**TOWN OF MOUNTAIN VILLAGE
REGULAR DESIGN REVIEW BOARD MEETING AGENDA
THURSDAY JULY 11, 2024, 10:00 AM
MOUNTAIN VILLAGE TOWN HALL
455 MOUNTAIN VILLAGE BLVD, MOUNTAIN VILLAGE, COLORADO
TO BE HELD HYBRID THROUGH ZOOM:**

4.	10:17	30	Nelson/ Applicant	Quasi-Judicial	Consideration of a Design Review: Final Architecture and Site Review for Lot 166AR2-10, 10 Stonegate Dr, pursuant to CDC Section 17.4.11.

PROJECT NAME:
SINGLE FAMILY
LOT 10, STONEGATE
MOUNTAIN VILLAGE, CO

3 North Elevation
SCALE: 1" = 10'

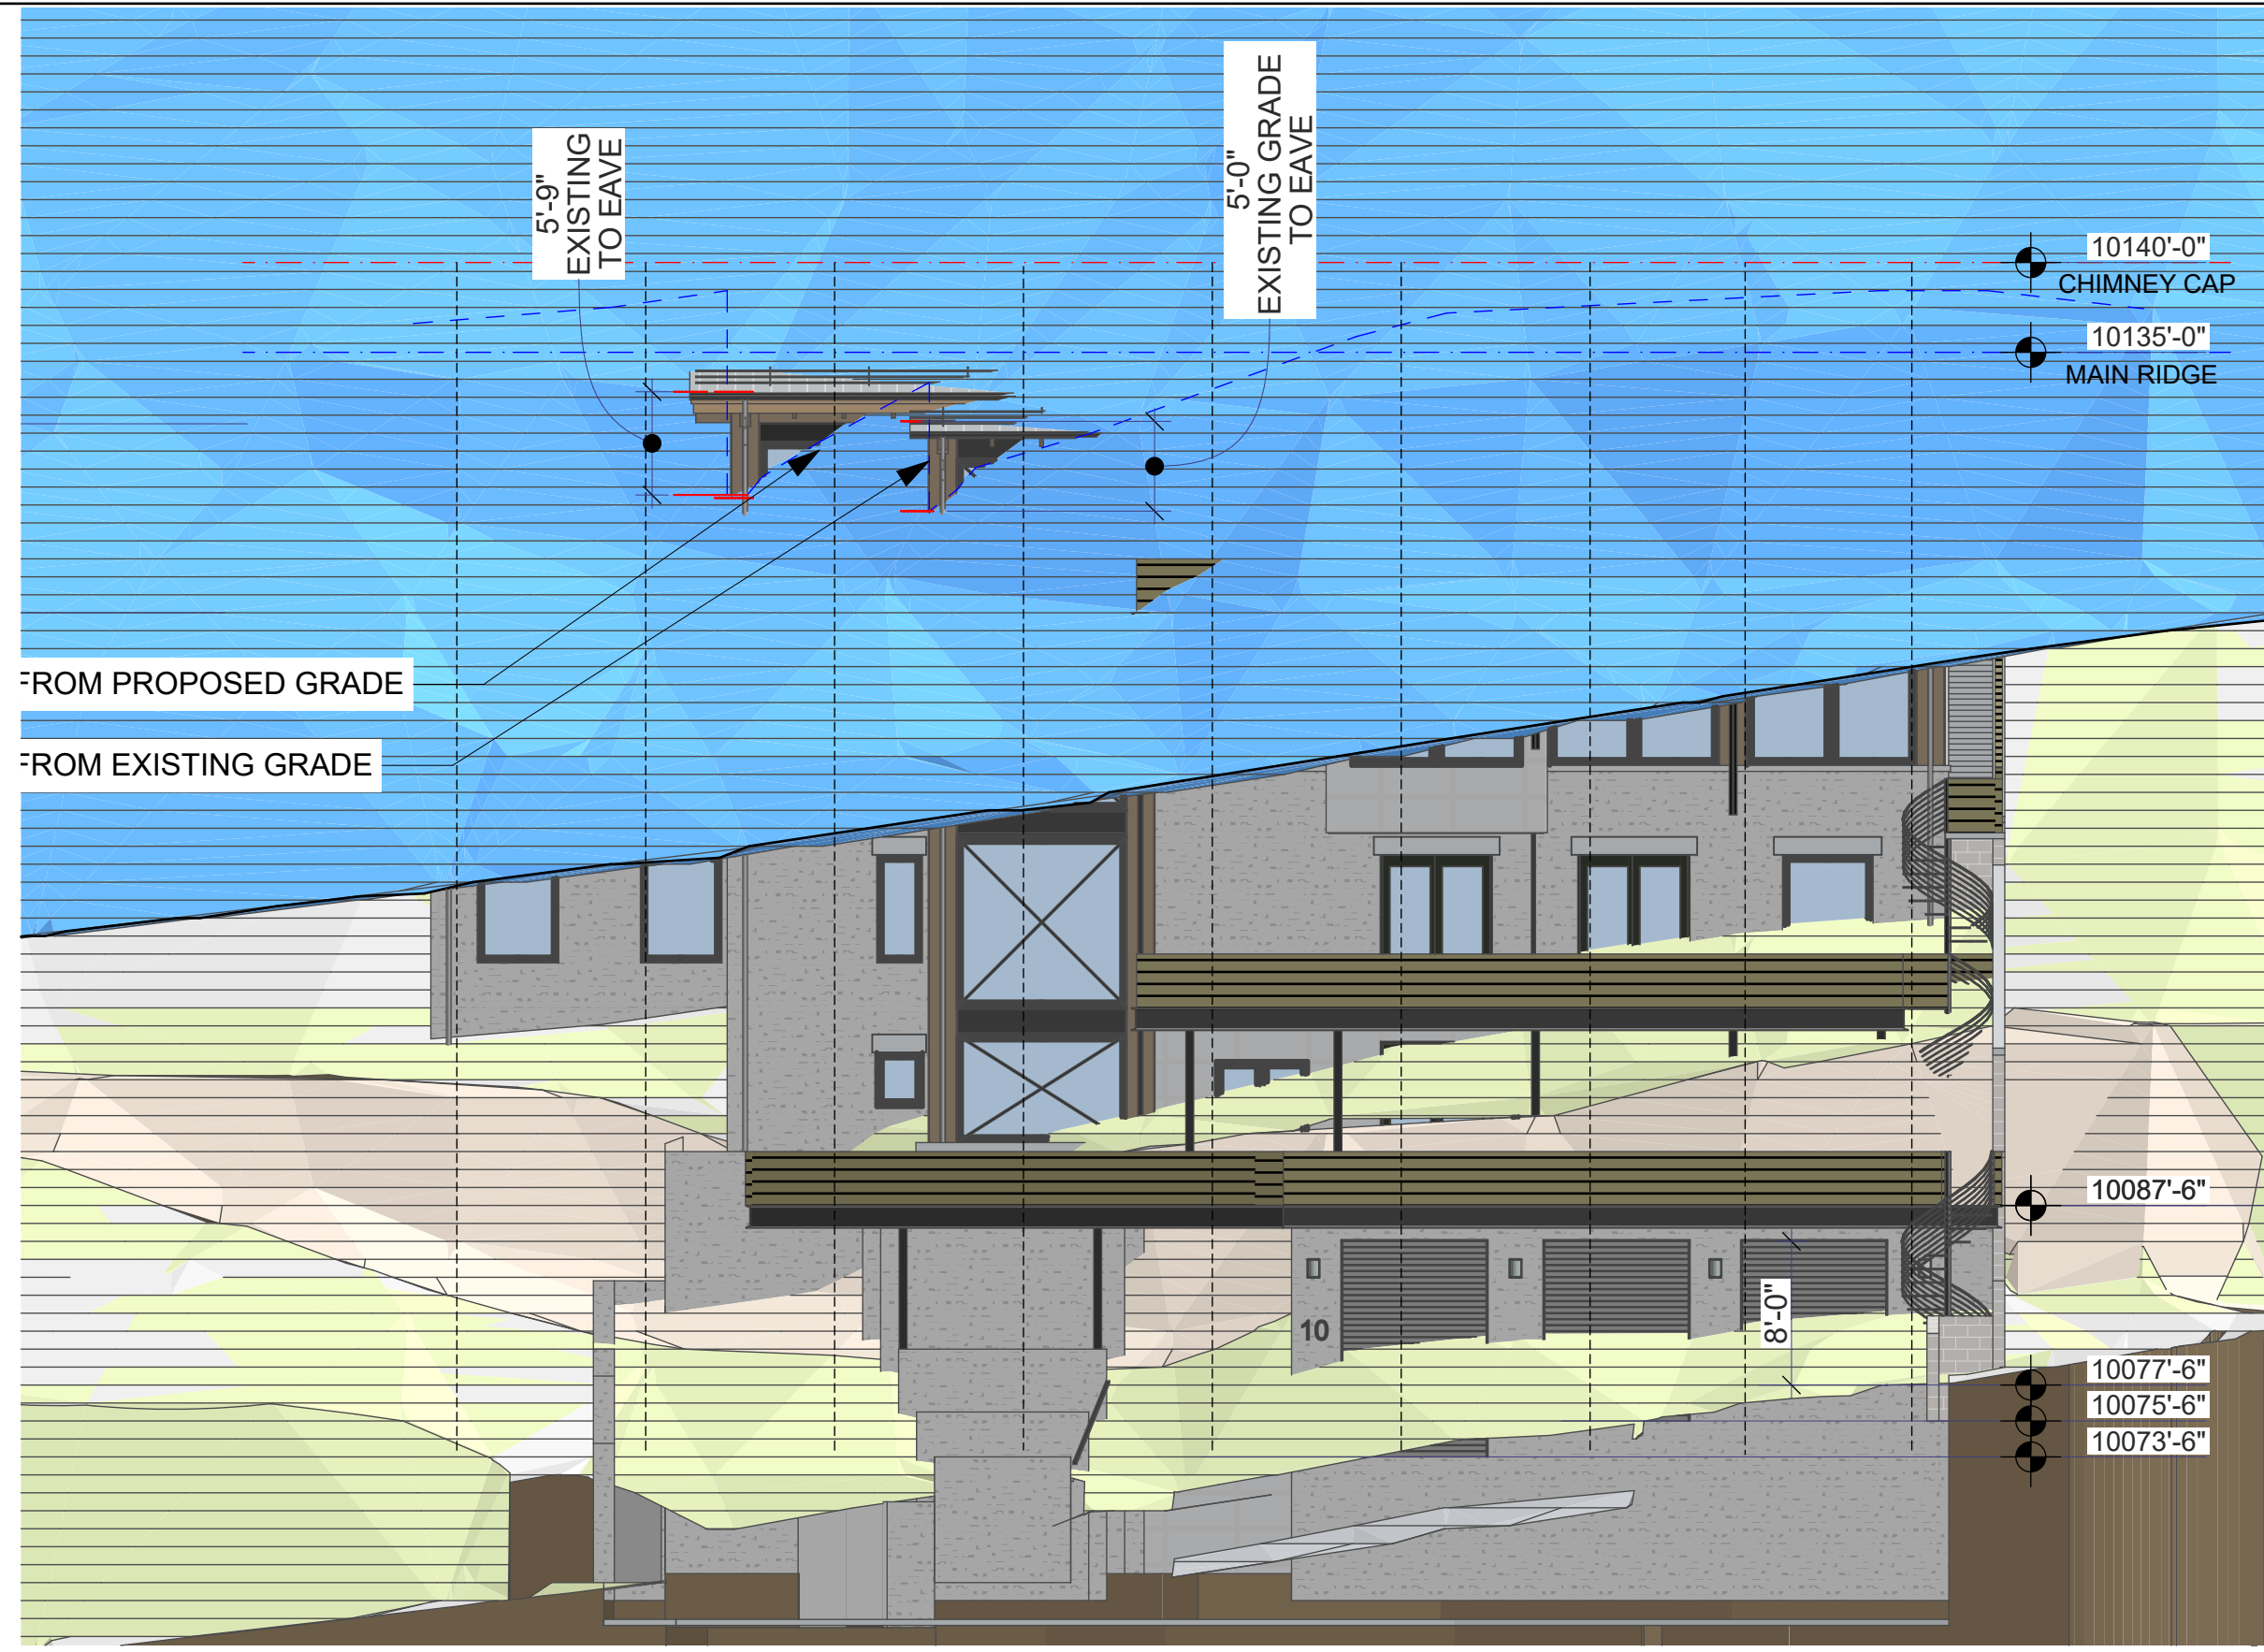
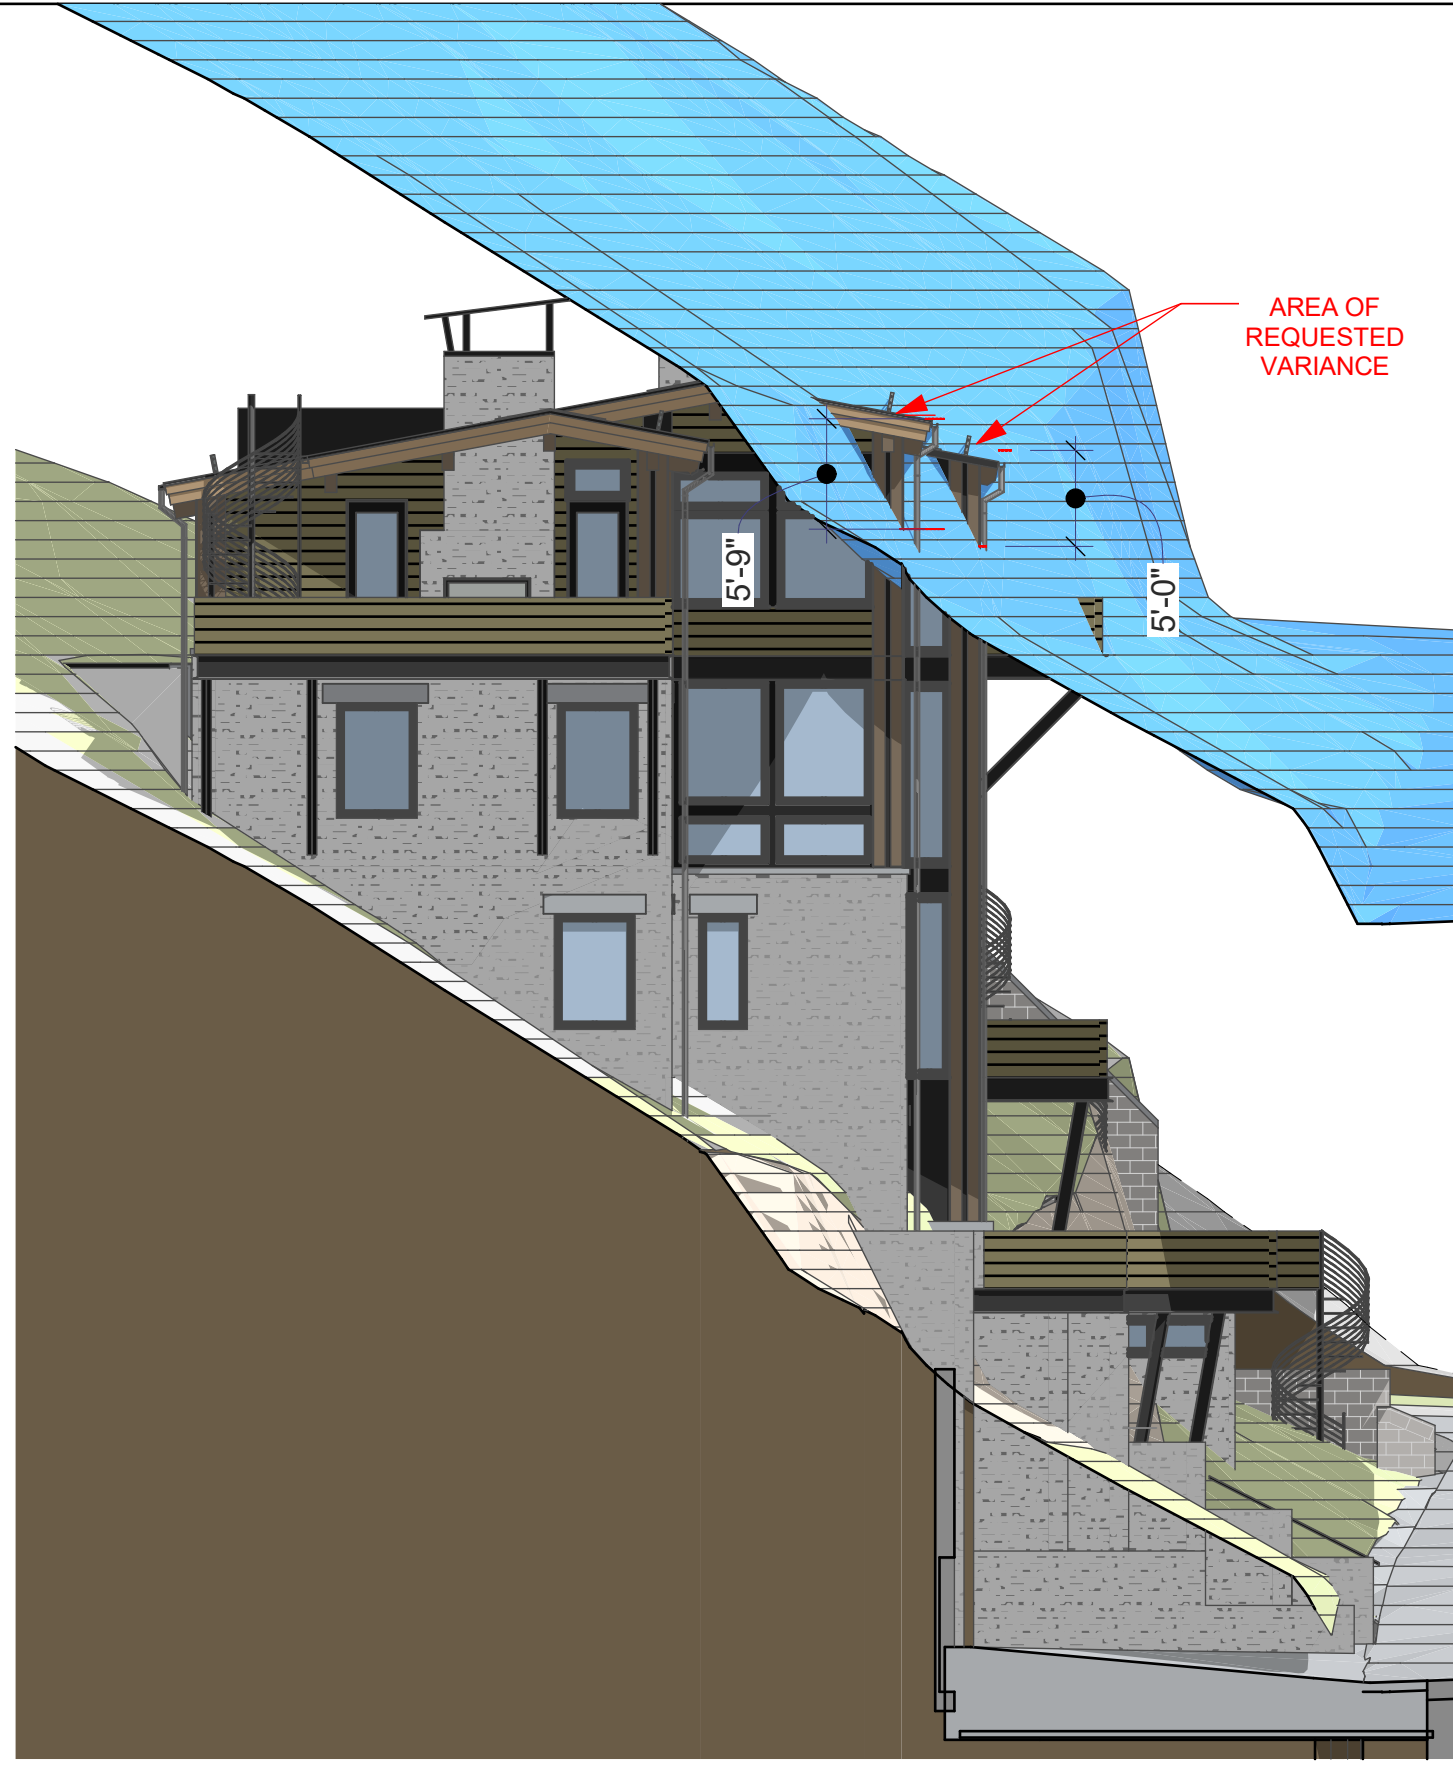
Staff: The primary roof form of the proposed structure is gabled and is therefore granted a maximum height of 40 feet and an average height of 35 feet. The applicant has indicated that the maximum height of the current proposed structure is 45.67 feet and has an average height of 27.59 feet (Sheet A-009 of the attached plan set). The CDC requires that height is demonstrated relative to both existing and proposed grade and that the most restrictive measurements be used to determine height. The Town Council approved a height variance of 6 feet above the maximum at their May 16, 2024 regular meeting.

The subdivision plat for Stonegate also includes a more restrictive plat note for building heights. The plat states that the overall building shall not exceed the USGS elevation of 10,135' and that chimneys shall not exceed 10,140', which the plan set indicates is being met for the home design.

Figures 2-5 show the elevations as they relate to the natural grade of the proposed structure and Figure 6 shows the 40' parallel offset to show portions of the structure above the 40-foot threshold.
